Application for Planning Permission. Town and Country Planning Act 1990

Design and Access statement Aura House, 2a New Road, Havant.

Resubmission of APP/16/00928

From: David Eaves <David.Eaves@havant.gov.uk>
Sent: 10 March 2017 10:15
To: Tom Peters
Subject: RE: Aura House APP/16/00928

PROPOSED NORTHEAST SIDE
ELEVATION

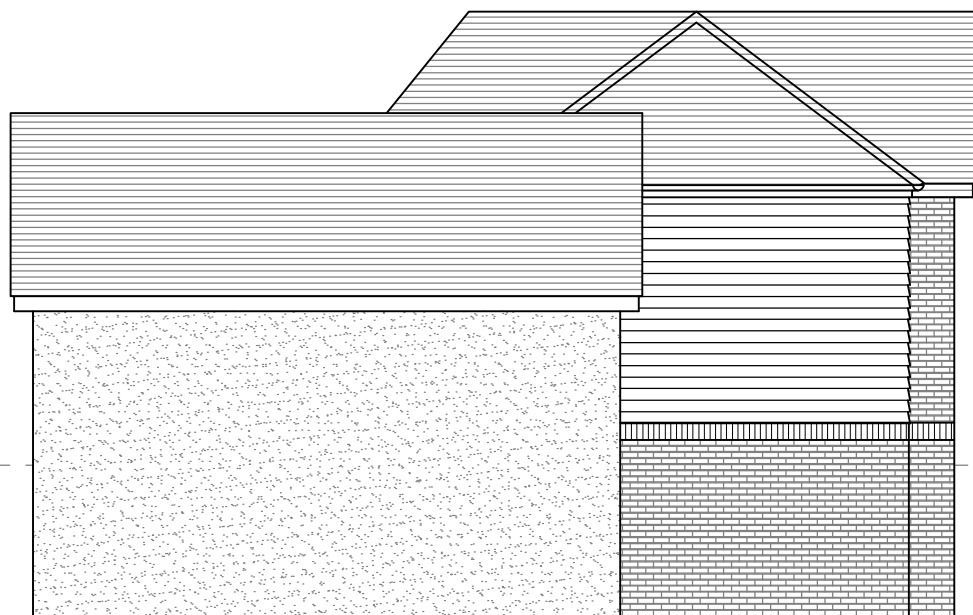
1. I can confirm that the proposal to use matching materials is considered to represent an improvement to the previous scheme and would help in making the building pick up on the character of the existing main building.

FRONT ELEVATION

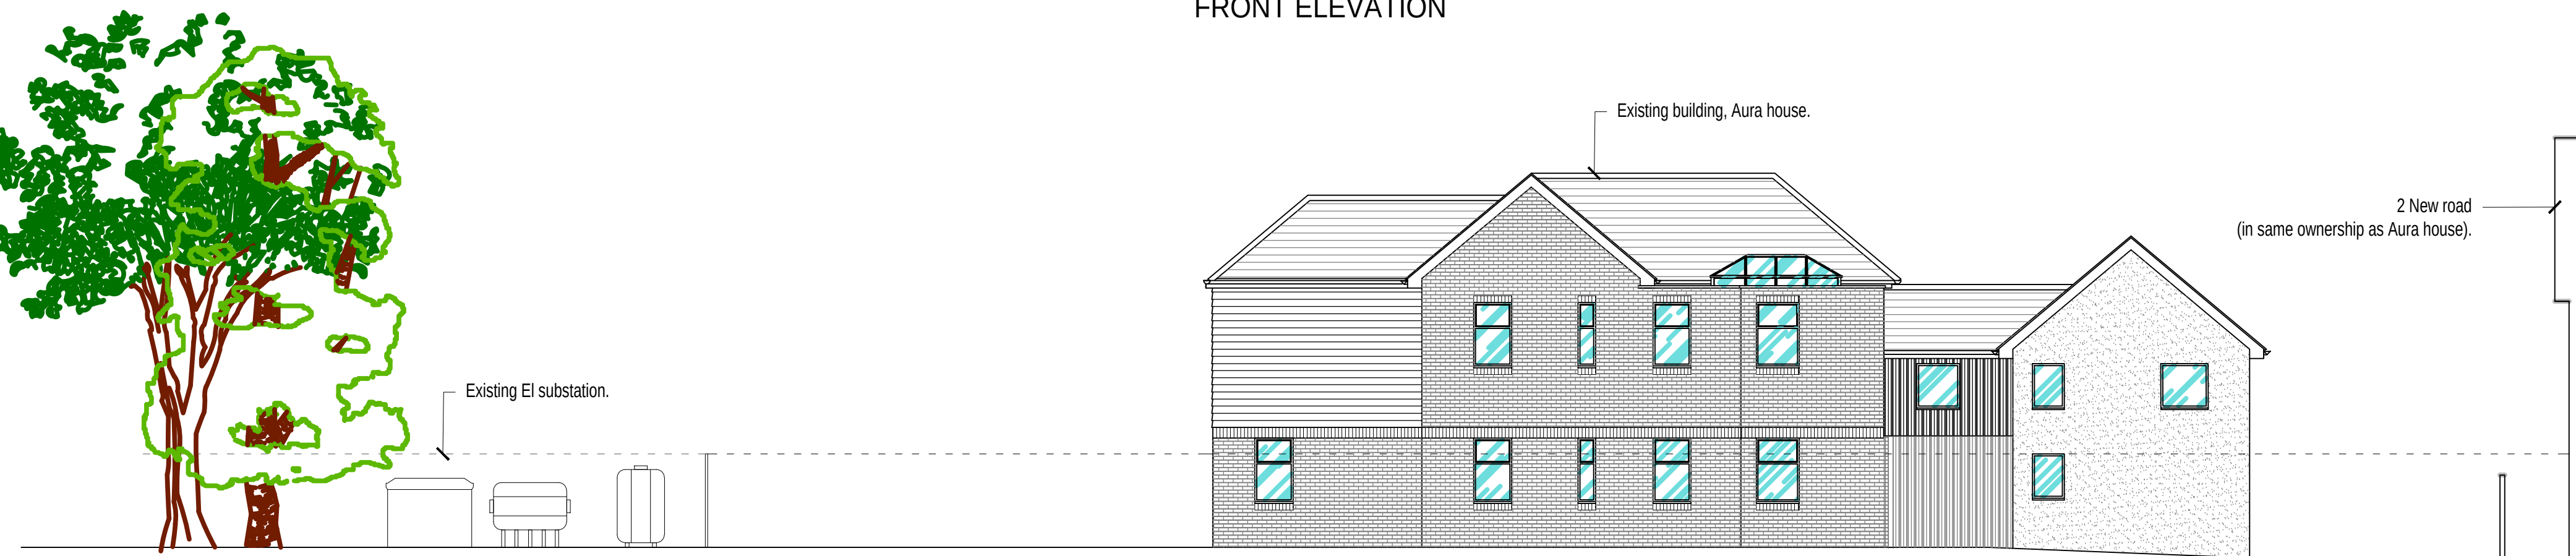
2. The simplified roof design again links to the design of the main building and is considered an improvement to the previous proposal.
3. I would recommend that an alteration to the front elevation is made . The central three light window should be changed to two single light windows spaced regularly with the other two windows. This would allow for the front gable feature to read visually as being 'supported' by the wall below it rather than the eaves line finishing above the window.
